Rail Committee Staff Report

Report #: 2302-0973

Approve the refined conceptual plans for the Partial Underpass Alternative at Churchill Avenue and the Underpass Alternatives at Meadow Drive and Charleston Road.

Figure 2: Rendering of Kellogg Avenue (looking west)

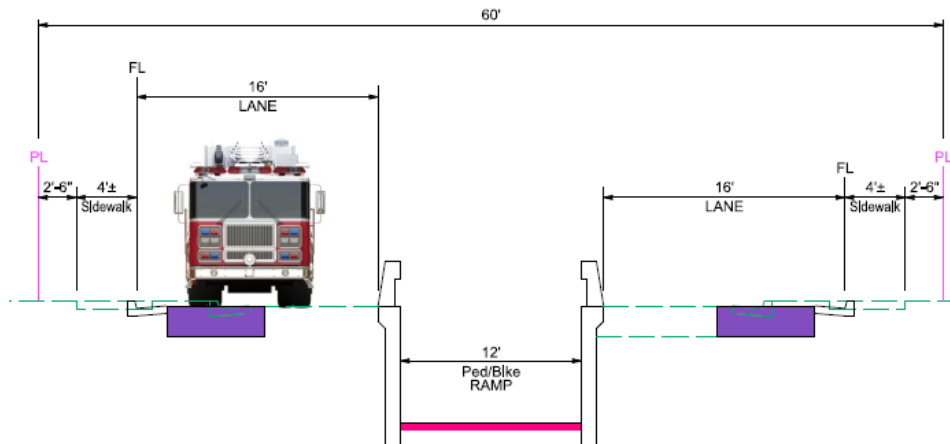
The width of the bicycle and pedestrian ramps is proposed to be increased from 10 feet to 12 feet, if possible, without significantly affecting the right of way. The plans have been updated to reflect the wider pathways. The lane widths on Kellogg Avenue have also been increased to accommodate emergency vehicles. The Palo Alto Fire Department concurred with a reduction of up to 4 feet of the California Fire Code requirement of 20 feet, allowing for a 16-foot roadway width on Kellogg Avenue, which will be achieved by removing the landscaping strip between the roadway and sidewalk. It will result in reduced frontage landscaping for property owners and will likely also need undergrounding of existing utilities. The proposed improvements are shown in the Plan View of Kellogg Avenue and Rendering in Figures 1 and 2 below. Figure 3 shows a cross-section view and provides dimensions. Similar improvements can be implemented at Seale Avenue if Peers Park is chosen as the preferred location for the ped/bike undercrossing.

Figure 5: Rendering of the Kellogg Avenue Tunnel at Embarcadero Bike Trail.

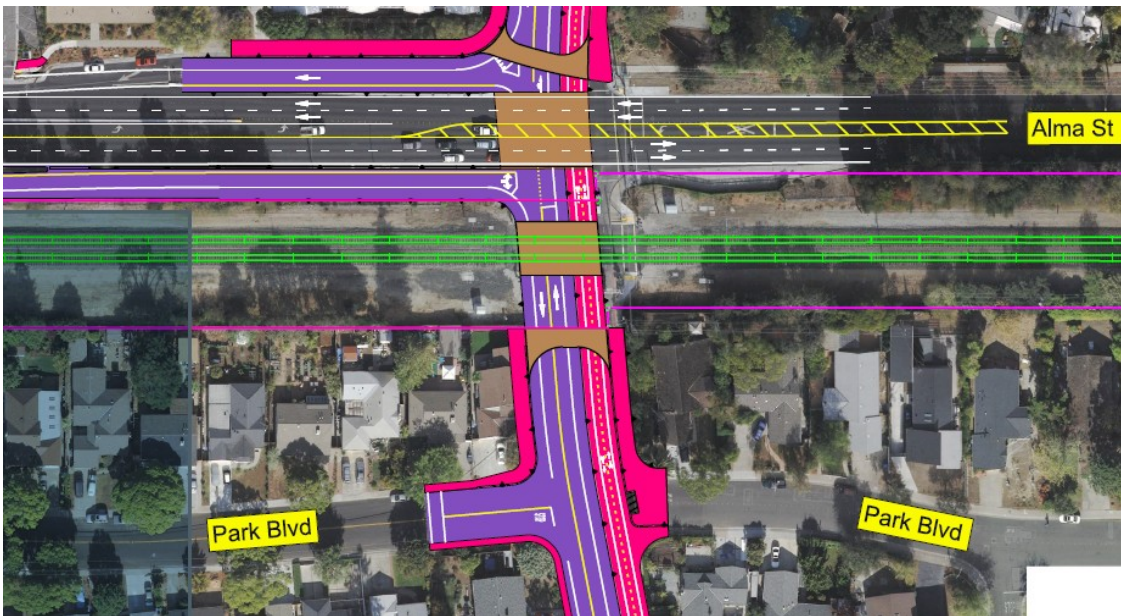
The feedback about the design bicycle and design speed was considered in the refinement of plans. To improve the maneuvering ability and line of sight of bicyclists at each location, the turning radius was adjusted to accommodate standard bicycles, tandem bikes, and bike trailers. The modification is depicted in the following rendering, which shows the improved turning movements at Kellogg Avenue undercrossing (Figure 5) and Meadow Drive pedestrian bridges (Figure 6).

Figure 7: Bike Lane Configuration at Kellogg Avenue

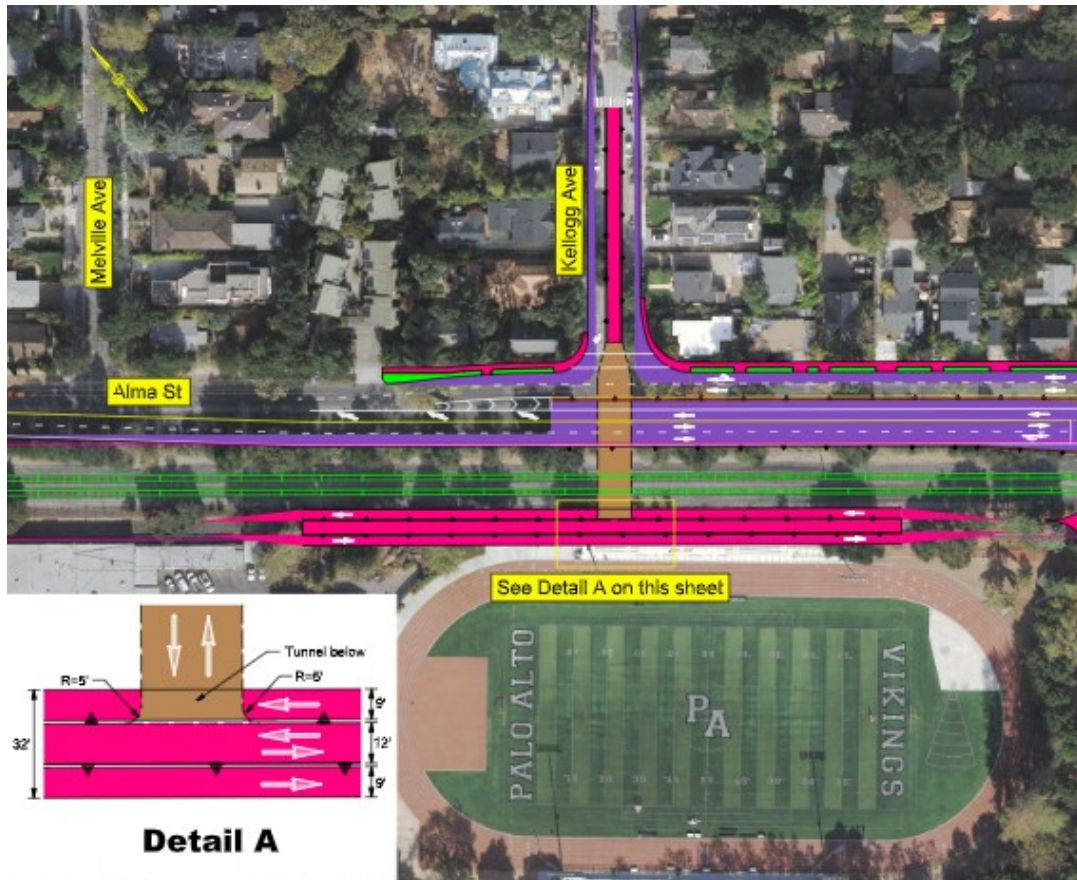
The consultant has performed an initial review at Seale Avenue to assess the feasibility of a bicycle and pedestrian undercrossing. A preliminary conceptual plan showing the conceptual alignment is developed (Figure 8). The concept utilizes space available in Peers Park to daylight the undercrossing on the west side of the railroad. On the east side, a configuration will be similar to the currently proposed concept at Kellogg Avenue (Figure 7).

Figure 9: Charleston Road looking west; showing a 2-way bike path on the north side of the roundabout.

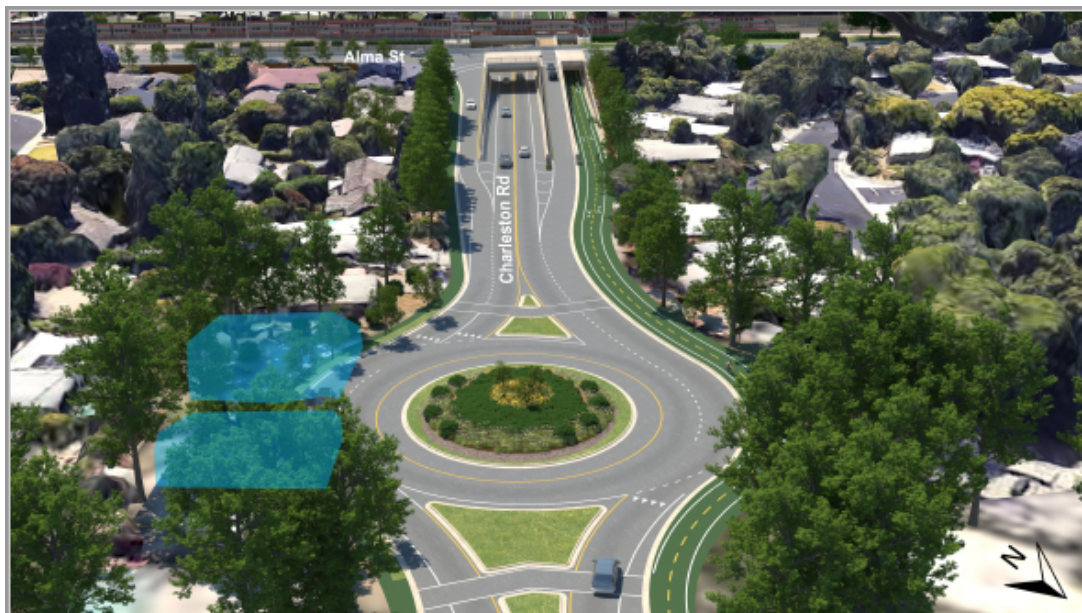
A bike lane extension was also reviewed to extend to the bicycle and pedestrian path from its current termini at Mumford Place to the intersection of Carlson Court (Figure 9). Due to right of way constraints, the bicycle and pedestrian path width will be narrowed from 20 feet on the west side of the roundabout to a twelve (12) foot Class I facility from the east side of the roundabout to Carlson Court. This extension of the Pedestrian and Bicycle Path may also require undergrounding of existing utilities

The initial review indicates that the right-of-way constraints will result in the elimination of the existing landscaping in this segment to provide a shared Class I bicycle and pedestrian path. A detailed review will need to be performed during the preliminary engineering design to propose alternative landscaping and to review the roadway cross-section in this segment.

Figure 10: Alma Street at Kellogg Avenue; showing buffer between the sidewalk and travel lane

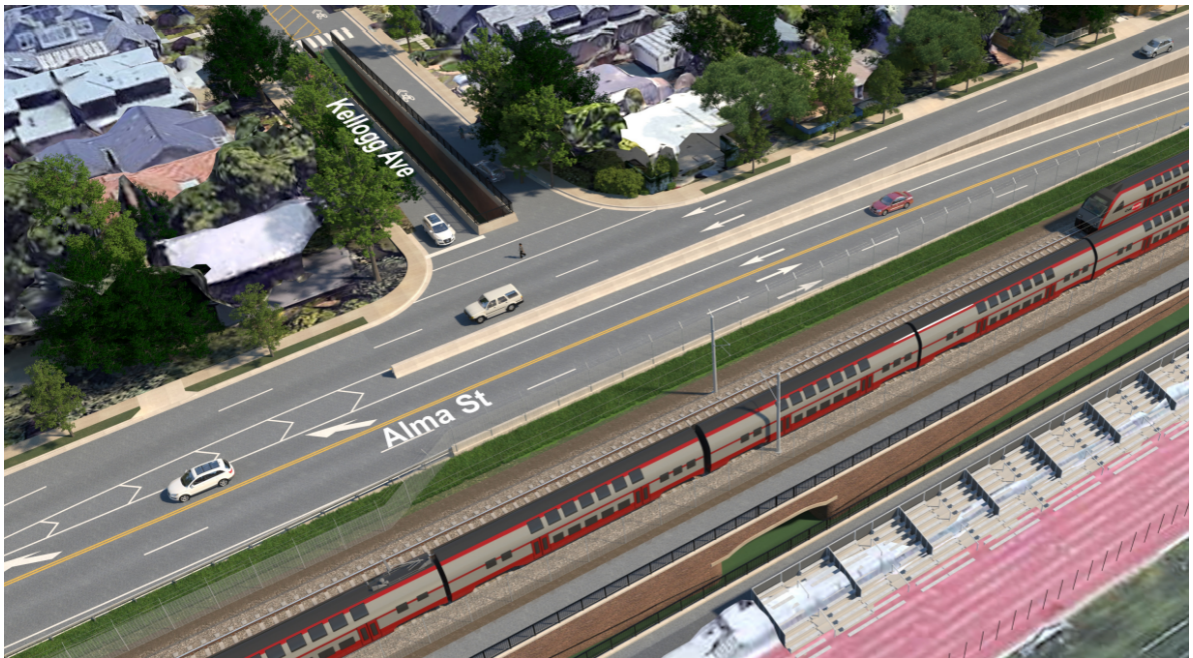
In previous study sessions, the members of the Rail Committee expressed their concerns regarding the contiguous sidewalk along Alma Street and emphasized the need for a buffer between the sidewalk and curb to create a safer environment for pedestrians. The plans for Churchill Avenue and Charleston Road now propose a four-foot-wide strip of landscaping that will serve as this buffer zone (Figure 10). Implementing this buffer segment will lead to an increase in right-of-way required and will also necessitate adjustments to the existing driveways. The buffer zone will limit the availability of right-of-way for existing utilities thereby requiring additional undergrounding of existing utilities

Figure 11: Charleston Road looking west; showing a 2-way bike path on the north side of the roundabout.

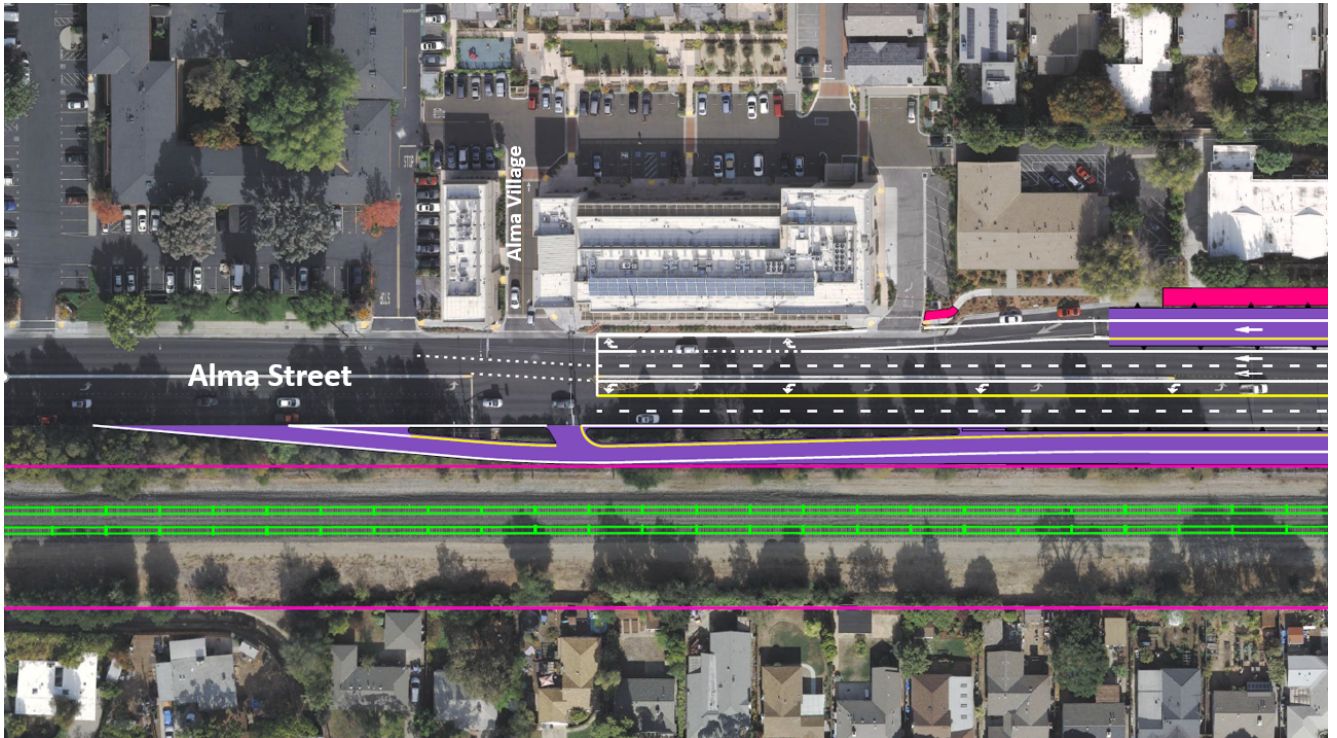
During the review of turning movement, it was noted that U-turns at Alma Village and Alma Street intersection will only be feasible for regular passenger vehicles. Therefore, the U-turns will be restricted for trucks at this intersection (Figure 11).
